Technical Service Bulletin: tsb100266

Spacer for Turbocharger Oil Supply Line Bracket

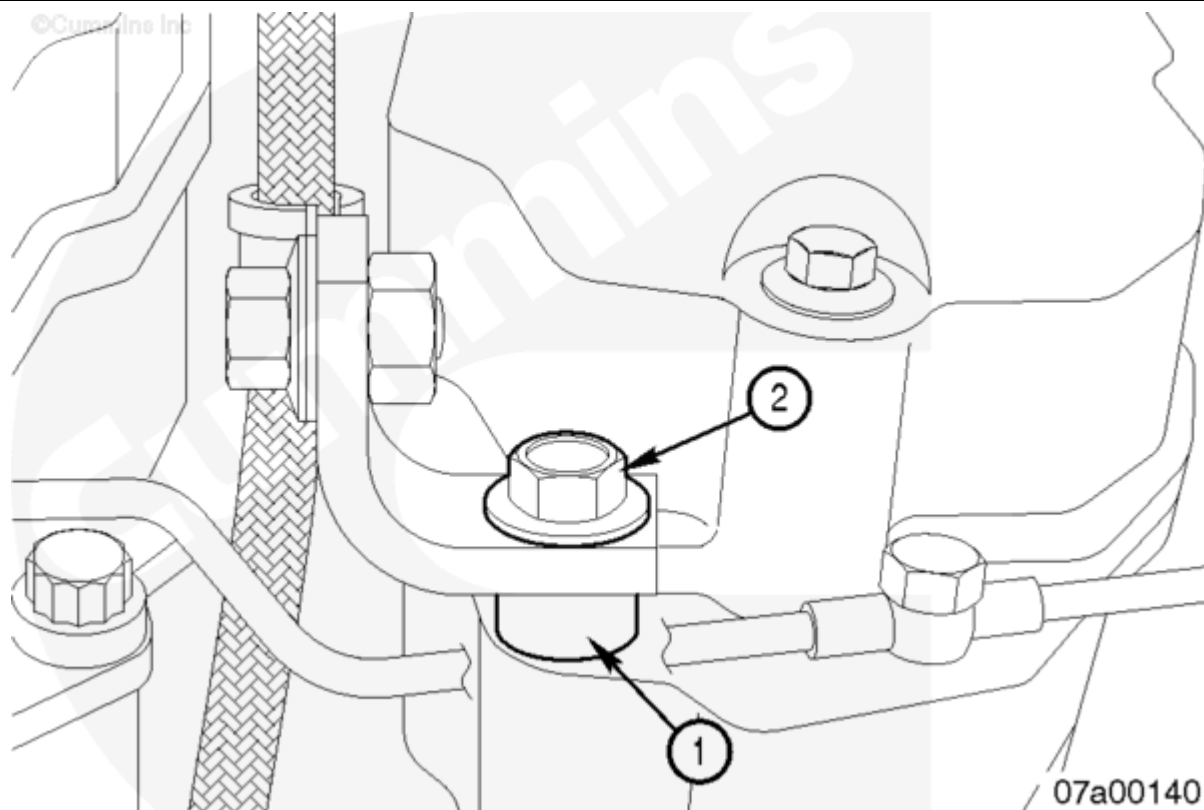
This Technical Service Bulletin announces the release of a turbocharger oil supply hose bracket spacer for the QST30 engine. The bracket spacer was implemented to reduce the possibility of contact between the turbocharger oil supply hose and the fuel return tube. The spacer, Part Number 3092334, is placed under the existing oil supply hose bracket mounted to the rocker lever housing. The new spacer requires a longer capscrew, Part Number 3094813, due to the addition of the spacer. This spacer and capscrew are used on both the left and right banks of the engine.

The illustration below shows the proper installation of the new spacer (1) and capscrew (2).

The new spacer and capscrew have been implemented into production on all QST30 engines starting August 14, 2003, with engine serial number first 37208615.
